Scale	1:20@A3
Date	14.01.2025
Drawn/Checked	JDK/DRP
4035-20-AWSM-XX-XX-DR-A-3060	
Status	S0 Rev P2

Typical PROW Steps

Blue Hills Farm

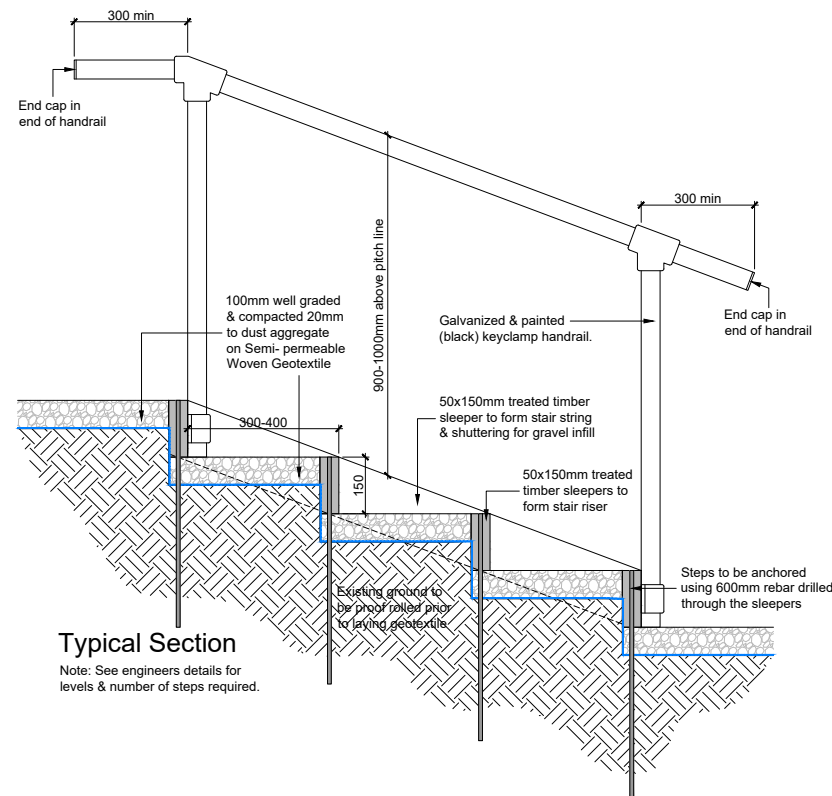
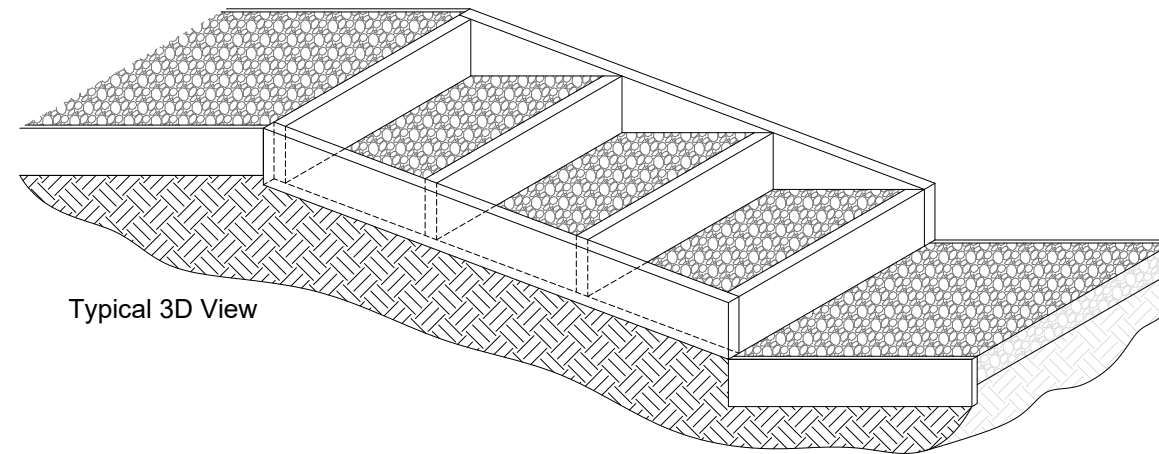
Rev P2 24.09.25 JDK
Sleeper fixing detail & handrail type updated following Planning comments.
